Foothill Street Solar Project

MEMORANDUM

TO: Planning Board, Town of Yorktown
From: Edward Kolisz, Fire Inspector
Re: **Foothill St. Solar Farm**
Date: October 29, 2021

Re: Response to Outside Consultant Environmental Review Comment Letter
Con Edison Clean Energy Businesses, Inc.
Yorktown A Solar Project
3849 Foothill Street
Yorktown, New York
2478.001.001

Figure 1:
A-Weighted Sound Level Contours
 due to the Yorktown A Solar Farm

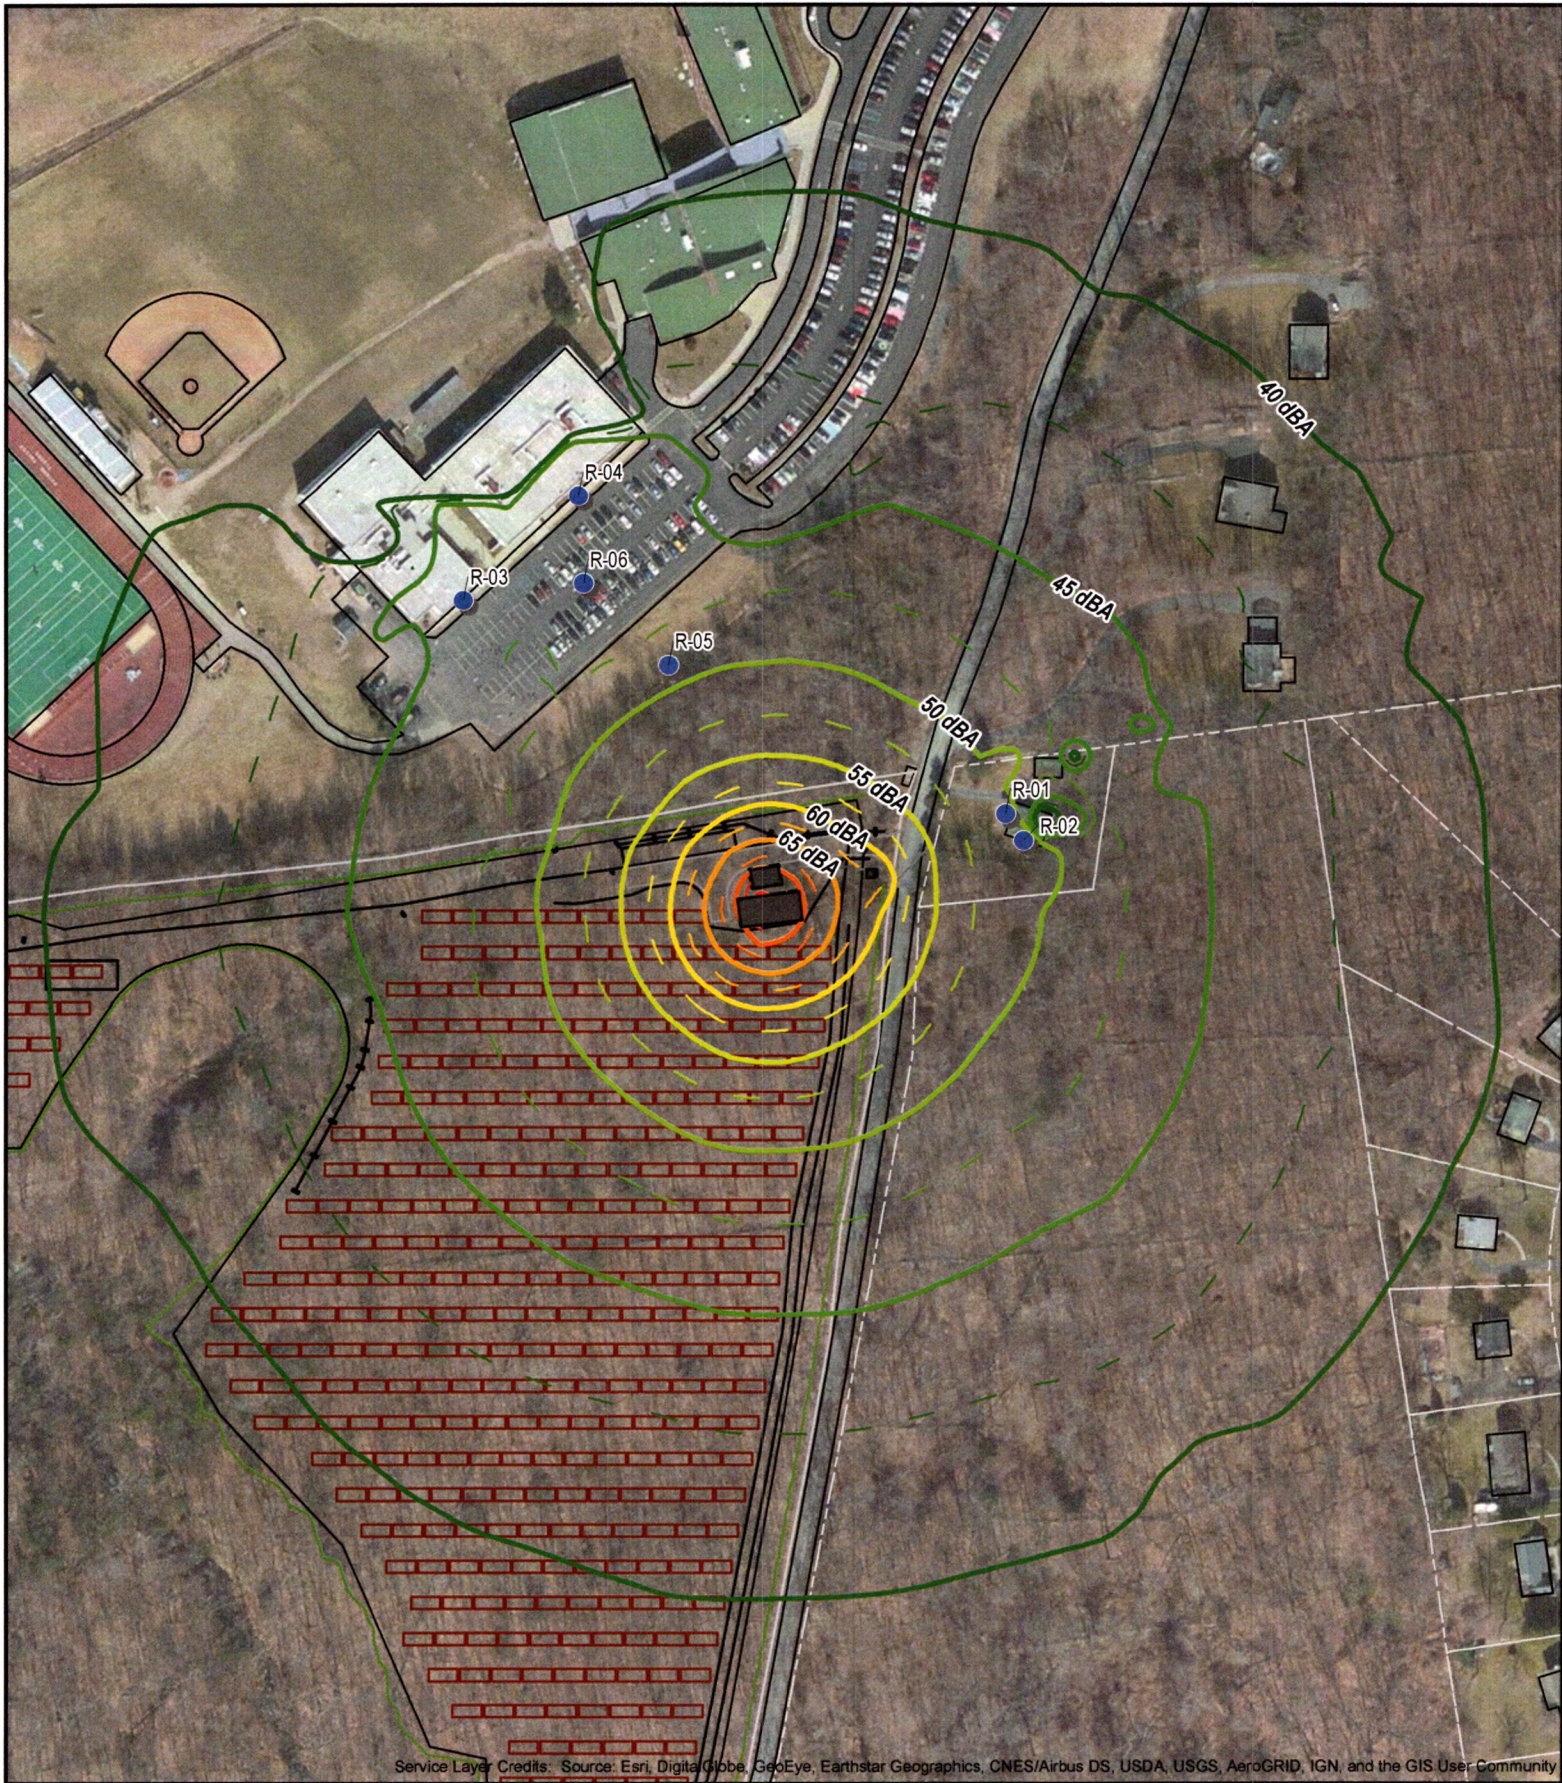
1. Please show the actual locations of all the invertors and recalculate the decibels in relations to said locations. All invertors would not be placed where shown Figure 1.
2. Please depict the Wellness Trail on the noise analysis and ensure that the proposed development will not affect the Wellness Trail.
